ACE Board Rev 1.0: Build Notes

The work an ACE Board Rev 1.0 needs beyond its bill of materials, for a new build or for upgrading a built board. Rev 1.1 makes these fixes on the PCB. On Rev 1.0 you make them by hand.

Figure 1. Top of the ACE. Where each change is. Change 5 is in two places: the ATmega, U6, and its pull-up under U4.

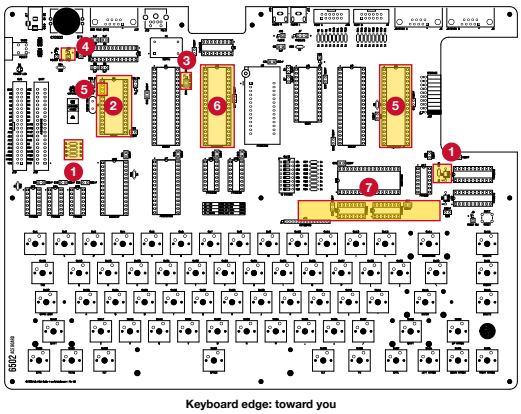
Change	Who needs it
1	Fit 10 kΩ at R1–R4 and R25, not 1 kΩ	Every board
2	Fit an R6551AP at U4	Every board
3	Keep J1 on its 1 MHz pins	Every board
4	Add a 10 µF supply capacitor on the underside	Every board
5	Program the AB Controller firmware, and add a 10 kΩ pull-up on RESB	Firmware: every board. Pull-up: recommended
6	Stack a socket on U3 and fit a diode for /INT	Any pico9918 video card
7	Fit the ACE RAM Patch Rev 1.1 in place of U12 and U13	Any board with the banked RAM (U15, U21, U22)

Figure 2. R1–R4, beside the CART connector. Note the order: R1, R4, R2, R3.

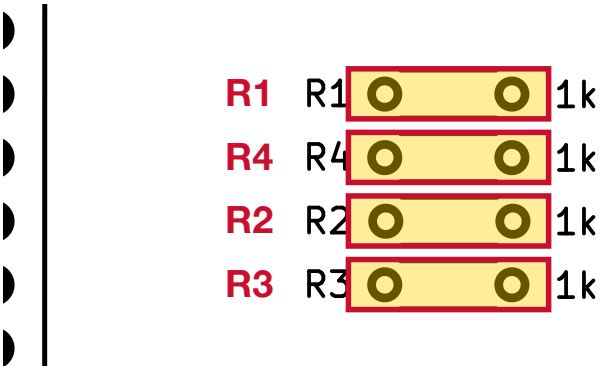
1 Pull-ups: R1–R4 and R25 are 10 kΩ

Rev 1.0's BOM lists 1 kΩ at these five places. Rev 1.1 changes all five to 10 kΩ. R1–R4 pull up shared lines: BE, RDY, NMIB and IRQB. A 1 kΩ pull-up draws 5 mA, more than the 3.2 mA the 65C22's IRQ output is rated to sink. R25 pulls up the banked RAM's chip enable (U15 pin 22). Every other 1 kΩ on the board stays 1 kΩ, including R5, which is the ATmega's reset pull-up.

- [ ] R1, R2, R3, R4: 10 kΩ.
- [ ] R25: 10 kΩ.

Figure 5. The capacitor across J20's pads, lying flat. Underside of the ACE, keyboard edge toward you.

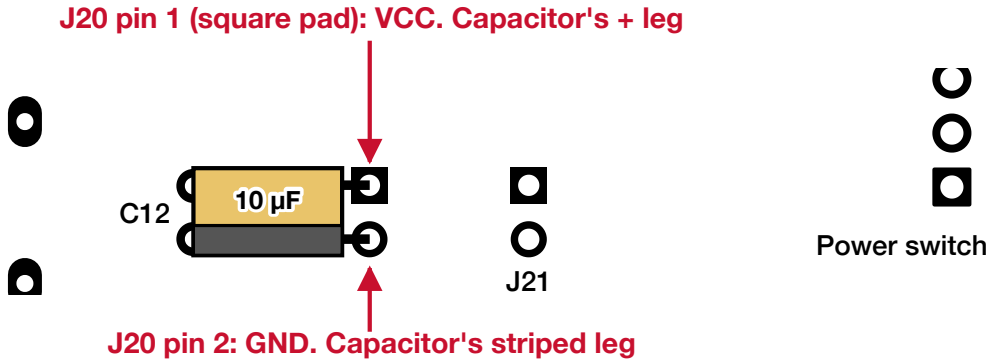
4 Add the 10 µF supply capacitor

Rev 1.1 adds a 10 µF electrolytic across VCC and GND beside the power input, as bulk capacitance for the whole board. Rev 1.0 has no holes for it, so it goes on the underside, across the pads of J20, the VCC header. J20's pads are close to the power switch and 2.54 mm apart, and J20 can still be fitted. Rev 1.0's own C20 is a 100 nF capacitor elsewhere on the board: leave it alone.

- [ ] Bend the legs to 2.54 mm. Positive leg to J20 pin 1 (VCC), striped leg to J20 pin 2 (GND).
- [ ] Lay the body flat on the board, so it stays clear of the plate. Its insulated sleeve can rest on C12's joints. Solder the legs to the pads, or to J20's tails if J20 is fitted, and clip them.

Figure 6. The RESB pull-up on the underside, keyboard edge toward you. U4's pin 1 is nearest the connectors.

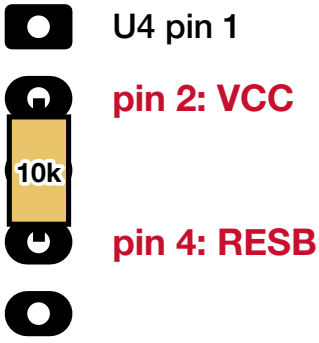
Fit the pull-up

The ATmega's internal pull-up raises RESB on its own, but a 10 kΩ is stiffer on a line that runs out to CART and BUS. Rev 1.1 has one. On Rev 1.0, U4's pins 2 and 4 are VCC and RESB, 5.08 mm apart, the same pitch as a resistor footprint.

- [ ] 10 kΩ across U4 pin 2 and U4 pin 4, on the underside. Pin 3 is between them: keep the legs off its joint.

Figure 7. Find pin 16: the fifth pin up from the keyboard end of U3's left row.

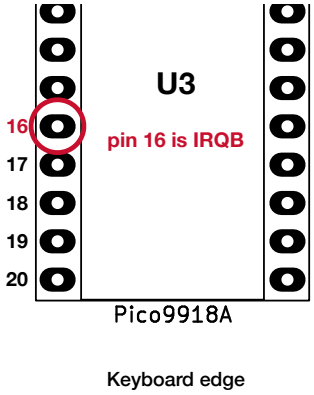
6 The /INT diode, on a socket stack at U3

U3 pin 16 is the video chip's /INT, and Rev 1.0 wires it straight to IRQB. A TMS9918A's /INT is open-drain, but every pico9918 drives it high as well as low, and holds IRQB at about 3.8 V while the VIA tries to pull it low. Keyboard and serial input are then dead. This affects the PRO and the v1.3 alike: a v1.3 can appear to work, but only by luck. Rev 1.1 has a diode on the PCB. Rev 1.0's PCB has no place for one, so it goes in a socket stack: a second socket between U3's socket and the card, with pin 16 routed through the diode.

- [ ] Take a machined-pin DIP-40 socket: this is the riser. The pico9918's pins are solid and can't be bent or cut, so the change is made here.
- [ ] Count to pin 16 on the riser, with its notch the same way as U3's. Cut off pin 16's tail below the plastic, so it can't reach U3's socket.
- [ ] Solder the BAT85's band end (cathode) to what is left of the riser's pin 16.
- [ ] Put the other leg (anode) into U3's socket at pin 16, and press the riser into U3's socket. Keep the diode under the card or on the board beside U3's left row, with its legs clear of the other pins.
- [ ] Check with the meter's diode test, with the card out: red on IRQB (R3's left leg, Figure 2), black in the riser's pin 16. About 0.3 V this way, and open the other way.
- [ ] Fit the card into the riser, with its pin 1 at the connector end. It now sits one socket higher: check that it clears any top panel.

Figure 9. Top of the ACE, keyboard toward you. The patch's four parts run in one row: U1, J1, J2, U2. J1 goes in U12's holes and J2 goes in U13's. Pin numbers are marked on both sockets.

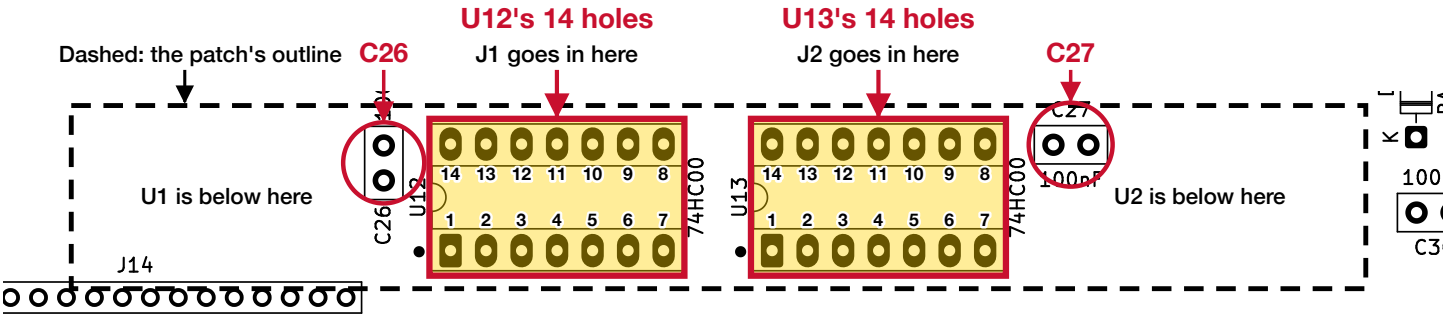
Rev 1.0's latches for the banked RAM load at the wrong times, so the RAM doesn't hold a bank. The patch is a small board that replaces U12 and U13. It mounts under the ACE on pin headers, with the same logic as Rev 1.1.

- ☐ U12 and U13 are empty: no chips and no sockets. On a built board, take them off. Take off an older Rev 1.0 patch or any other rework on this part of the logic.
- ☐ All 28 holes of U12 and U13 are open and clear of solder.

Figure 10. Underside of the ACE, keyboard toward you. Left and right swap, so U13 is left of U12. Red dots are the legs of C26 and C27. Numbered white circles show where the patch's U1 and U2 pins land, 2.54 mm below the ACE.

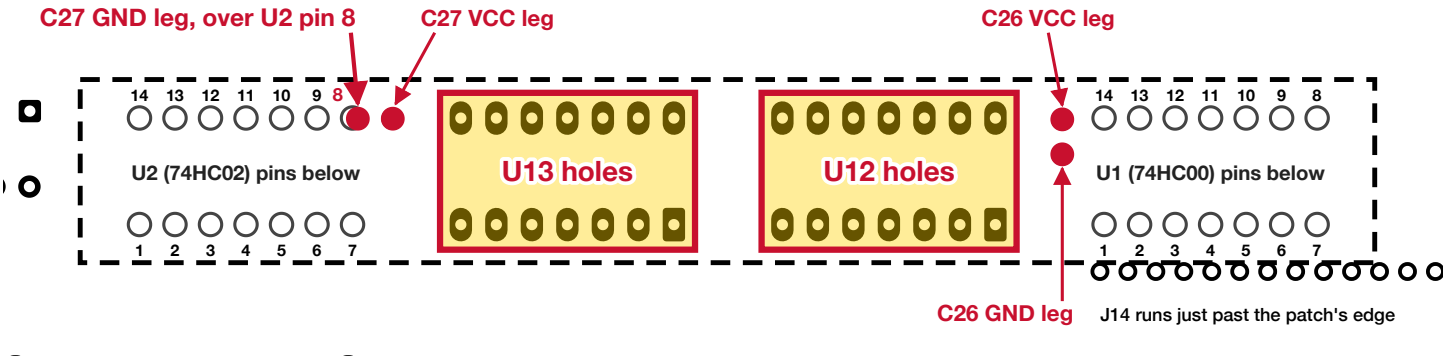
> **Watch C27:** its GND leg sits 0.38 mm off the center of U2 pin 8, with only the 2.54 mm header gap between them. U2 pin 8 carries the signal from U1 pin 8. If the leg touches the joint, that signal is shorted to ground. Step 2 deals with this.

- [ ] **C27 and C26:** clip all four legs to no more than 1 mm below the ACE. C27's GND leg matters most.
- [ ] The whole strip inside the dashed outline in Figure 10 is free of wires and parts.
- [ ] **J14:** its tails stand just past the patch's long edge, about 0.3 mm clear. Keep them straight.

Figure 11a. The patch's back: text upright. U2 (74HC02) is on the left and U1 (74HC00) on the right. Both have pin 1 at lower left, so both notches point left.

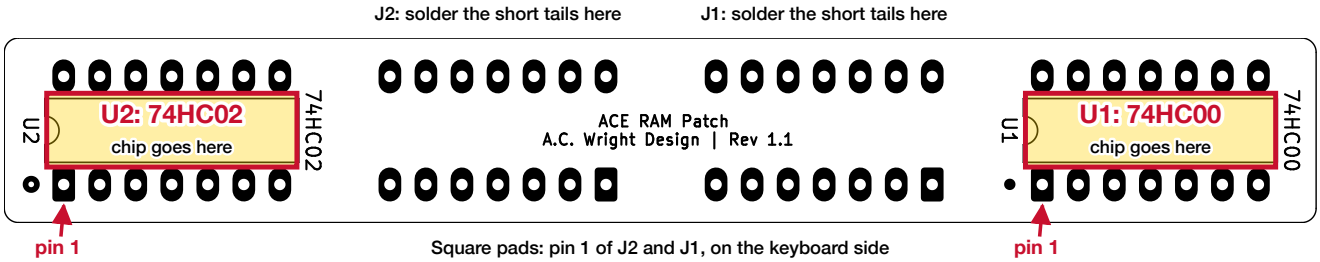
3 Solder U1 and U2 to the patch

- [ ] U2, the **74HC02**, on the left. U1, the **74HC00**, on the right. Check the markings: the two chips look alike.
- [ ] Notches to the left. Chips seated flat on the board. **No sockets:** a socket adds about 3 mm and the chip would hit the plate.
- [ ] Solder all 28 legs on the front. Clip them flush now: this side faces the ACE and you can't reach it later.

Figure 12. Steps 4 to 6: the ACE face down, seen from the keyboard edge (one row of pins, to scale). U2 is on the left in this view.

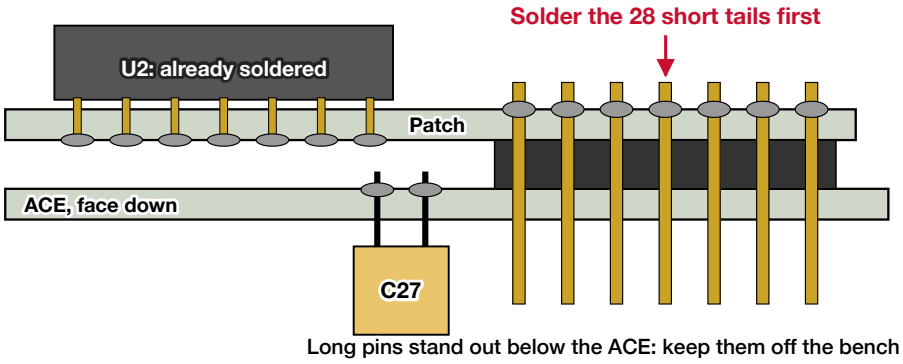
> **The patch also fits turned 180°, and that is wrong.** Every pin finds a hole, but VCC lands on GND (J1 pin 14 goes in U13 pin 7). Check all of these before any solder:

- [ ] Keyboard edge toward you, and the text on the patch reads **upright**.
- [ ] U2 (74HC02) on your left and U1 (74HC00) on your right.
- [ ] The patch's square J1 and J2 pads are on the keyboard side, under the ACE's square U12 and U13 pads.
- [ ] C27's and C26's legs don't touch the patch. Look through the gap with a light.

Figure 13. The finished stack, ACE on top, seen from the keyboard edge (one row of pins, to scale).

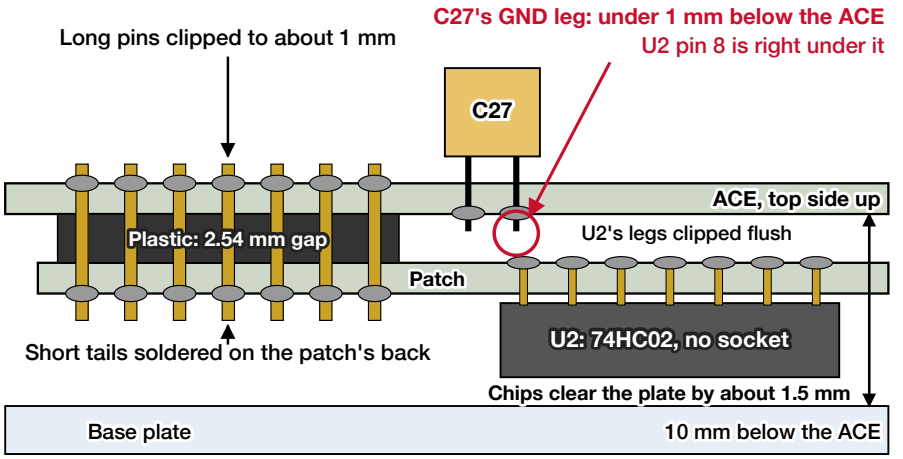
- ☐ The pins go in with finger pressure: use the strips.
- ☐ They need force: stop, and use round machined-pin header instead. Forcing a pin can damage the plated hole. Check that the chips still clear the plate (Figure 13).

- [ ] Turn the ACE face up. Hold it on blocks or its standoffs, so the patch hangs free. It hangs about 8.5 mm.
- [ ] Push the patch up, so the plastic is against the ACE's underside. Tack the end pins of each strip and check again.
- [ ] Solder the rest: 28 joints in U12's and U13's pads. Clip the pins to about 1 mm above the joint.
